AMCAL Multi-Housing, Inc. 30141 Agoura Road, Suite 100 Agoura Hills, CA 91301-4332 818.706.0694 WHA Architects 2850 Redhill Ave, Suite 200 Santa Ana, CA 92705 949.250.0607 October 23, 2017

Nov. 3 review letter (Police)

1795 Long Beach Blvd. Family Apartments Long Beach Blvd. at Pacific Coast Highway, Long Beach, California

Street & Bsmnt Lev A.1.1 Surveillance

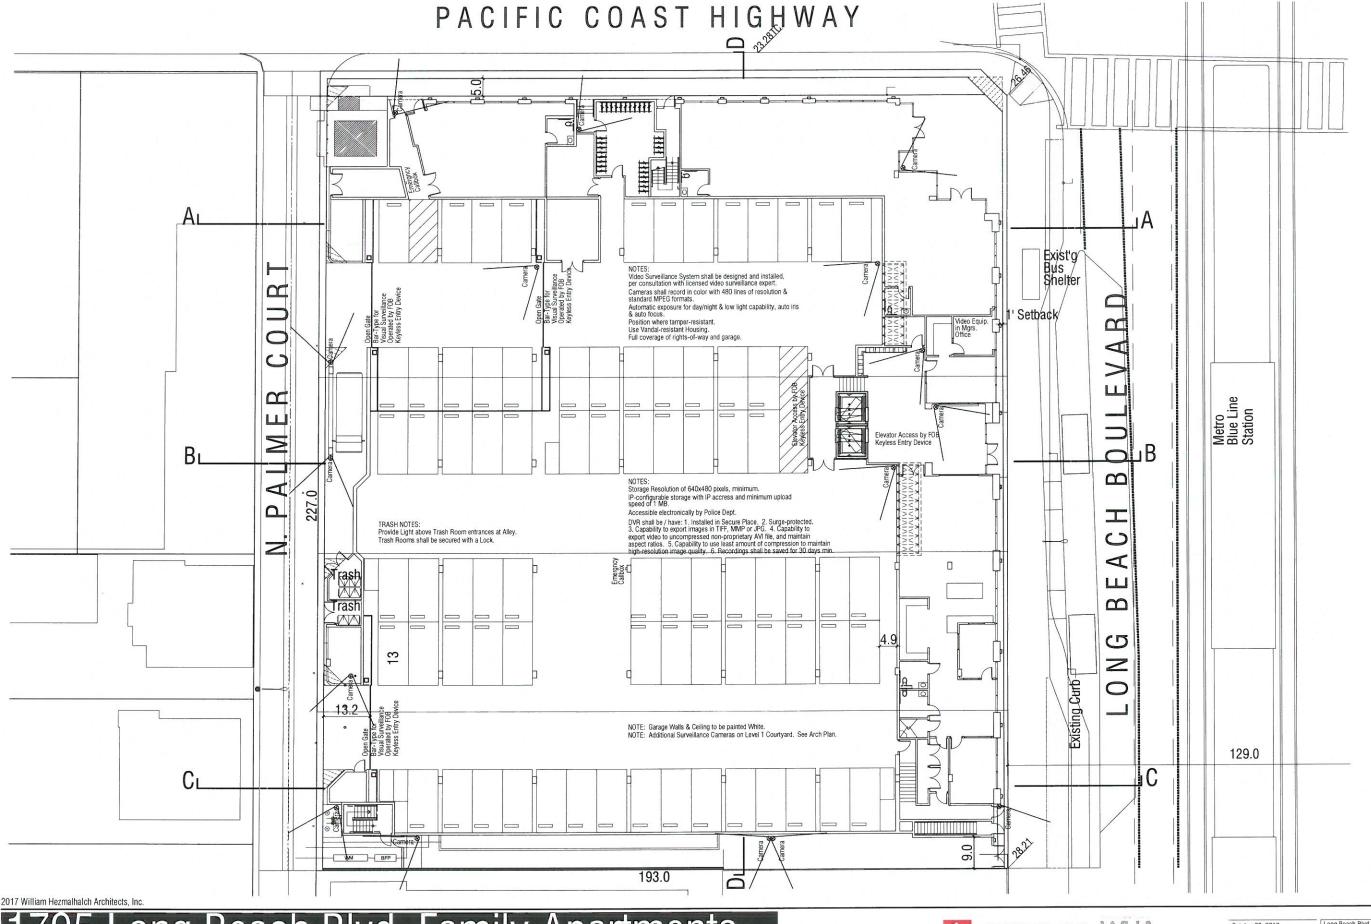
- A. Lighting location
- Lights are added to the pedestrian entrance and walkway on the south side, center ourtvard. Palmer Court side, PCH side, Long Beach Blvd. side, commercial garage, imercial garage entrance along Palmer Court (see new Lighting Plan).

- Wall pack lighting added to each side of building and above lobby, retail and other
- 3. Lighting added to walls of alcoves on perimeter of building
- 4. Lighting added above exterior signage.
- Note added: "Foot-candles shall be measured on a horizontal plane and conform to uniformity ratio of 4:1 average/minimum."

- Note added: "Video surveillance system shall be designed and installed, per consultation with licensed video surveillance expert."
- Note added: "Video surveillance system shall be designed and installed, per consultation
- South side pedestrian entrance and walkway. West side, facing Palmer Court.
- Courty ard.
 Pedestrian garage entrance on west side.
- Notes for camera specifications added: i. Cameras shall record in color with 480 lines of resolution and standard MPEG
- Automatic exposure for day/night and low light capability, auto iris and auto focus

- Garage

i. Note added: "Garage walls and ceiling shall be painted white."

ii. Architect plan shows that no interior walls are solid. Commercial and residential parking are separated by lower half wall and upper half fence.

iii. Video camera locations are noted on security/lighting plan.
 - Architect plan show light above trash enclosure entrance via alley Note added "Trash enclosure shall be secured with a lock."
- Note added "Foot-candles shall be measured on a horizontal plane and conform to
